SERVICE LETTER

Equipment Type(s): DA-1503B p/n 071-01593-0100 Antenna Drive

Subject: Field Modification of Units due to Manufacturing Error

Figure 2. DA-1503B Antenna Drive Counterweight Assembly

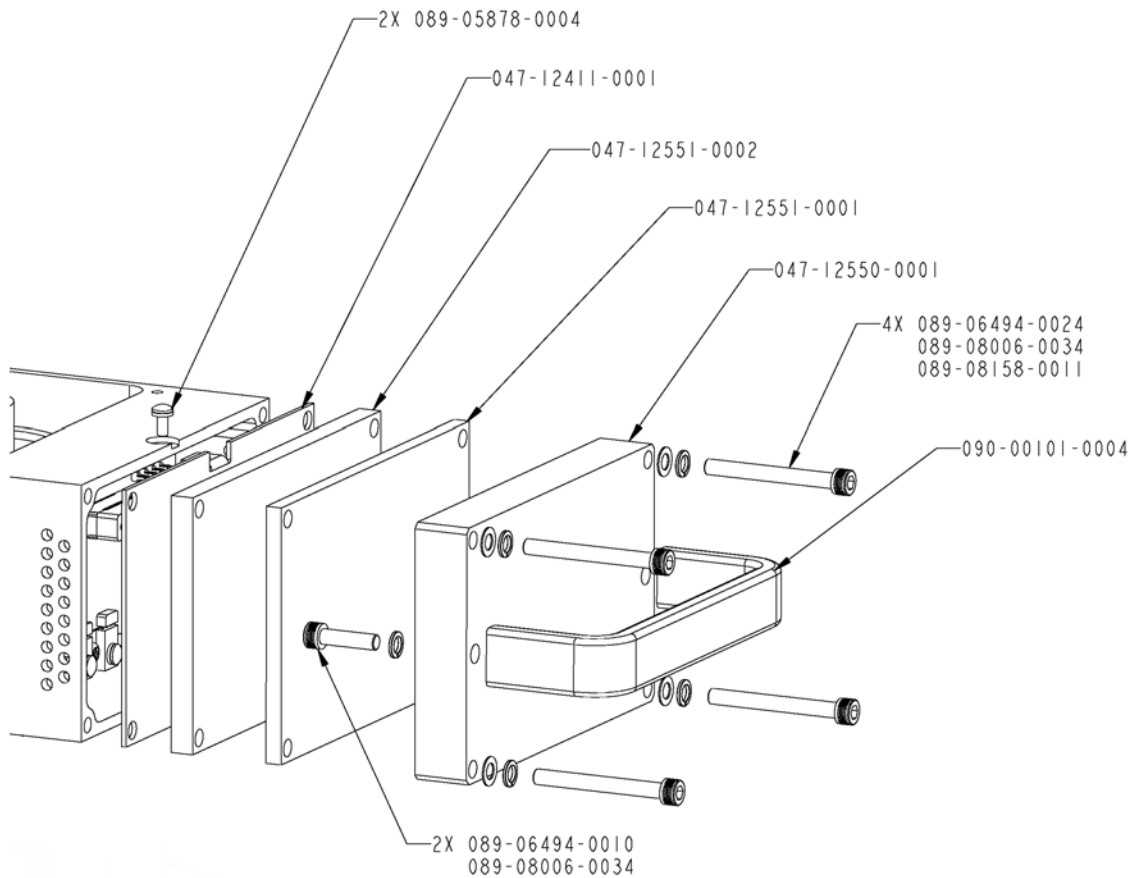
If the screw length is 1.25 inch, all four screws must be replaced with p/n 089-06494-0024 which is 1.50 inches long. See Figure 2 for disassembly and re-assembly guidance.

Repair Kit: The kit consists of four (4) screws p/n 089-06494-0024.
